VARIANCE REQUEST
COLONY VILLAGE RESTAURANT LAGOON
1982

RE: Proposed Lagoon Modifications and Variance Request
Colony Village Restaurant, Amana Interchange - I-80
Iowa County, Iowa

PRELIMINARY ENGINEERING REPORT
LAGOON MODIFICATIONS
COLONY VILLAGE RESTAURANT
AMANA INTERCHANGE I-80
NOVEMBER, 1982

Re: Proposed Lagoon Modifications
Plans and Specifications
Colony Village Restaurant
Interchange I-8, Iowa County
Project No. F-83-21

Schedule H1 - Schematic Flow Diagram

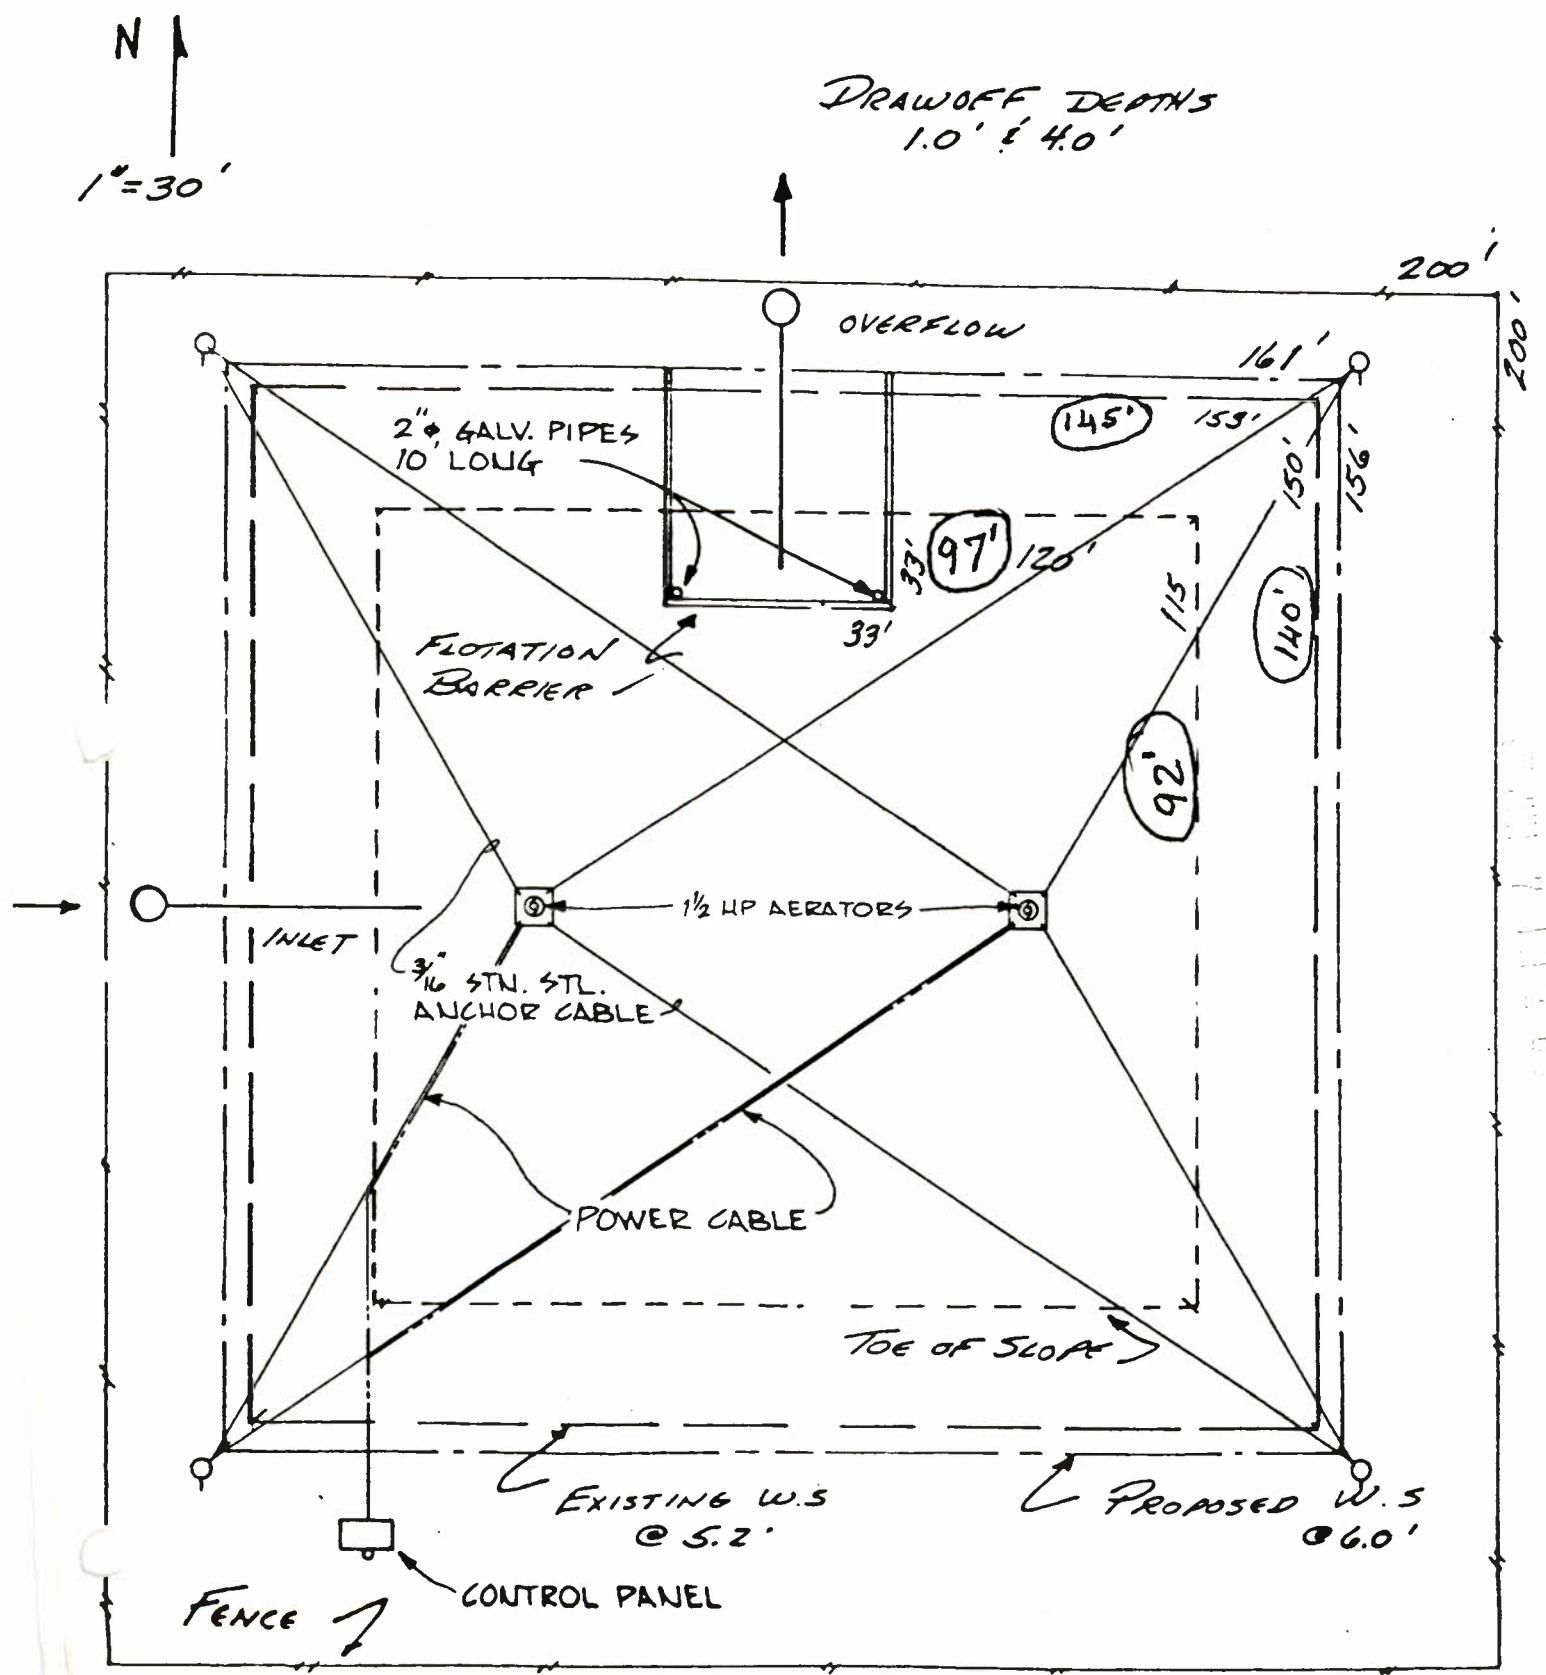
We have reviewed your request for variance to change the configuration of the proposed modification to the existing single cell controlled Discharge Lagoon for Colony Village Restaurant. After due consideration of the facts presented by you in your letter of May, 1, 1985, we are hereby granting you variance to allow one aerated cell, under the following conditions.

1. The aeration basin configuration has been changed to a single cell with a floating baffle provided to establish the quiescent cell. We would ask for a variance for the single aeration cell proposal and for the use of the floating baffle concept. The variance request is based upon the following justification.
 - a) Installation of a floating baffle (or any baffle) in the existing lagoon to provide two aeration cells would, in our estimation, prove detrimental to the process. As can be noted, the flow is only 10,000 gals/day, or less than 10 gpm. With this low flow, and less than a water tight baffle, flow would tend to short circuit to the quiescent cell, leaving the second cell with little flow through and effectively cutting the aeration time in half.

1. Two floating aerators shall be installed with capacity to maintain 2 mg/l of oxygen in all cells at all times.
2. One aerator shall be located close to the discharge of the influent pipe in the lagoon.
3. Submit revised plans, specifications and schedules A and K₂ incorporating the above conditions and requirements for our review.

We have also modified the Schedules K2 and H1, to reflect the above changes proposed, and would appreciate your earliest review and approval of the variance request and the plans and specifications.
